Technical Service Bulletin

39 Transfer case leaks

39 19 25 2016880/8 September 5, 2019. Supersedes Technical Service Bulletin Group 39 number 19-24 dated August 29, 2019 for reasons listed below.

Figure 1. The input shaft seal (A), and the front driveshaft output flange seal (B).

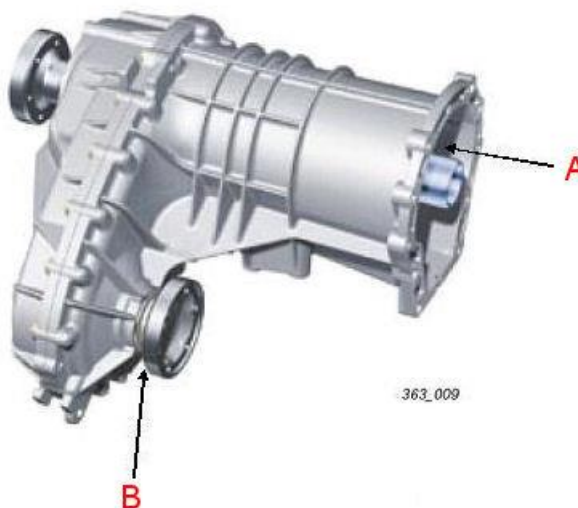
- Oil leak between automatic transmission and transfer case (Figure 1, A).
- Oil leak at front driveshaft output flange on transfer case (Figure 1, B).

- Transfer case input shaft seal is damaged during installation.
- The internal circlip of the output flange shaft has come loose, allowing the output flange to move out slightly, causing seal to leak.

1. Replace the transfer case input shaft seal (Figure 1, A). Refer to Elsa for seal installation instructions.
2. Replace the complete transfer case assembly if the front driveshaft output flange seal is leaking (Figure 1, B). Refer to Elsa for transfer case removal and installation instructions.
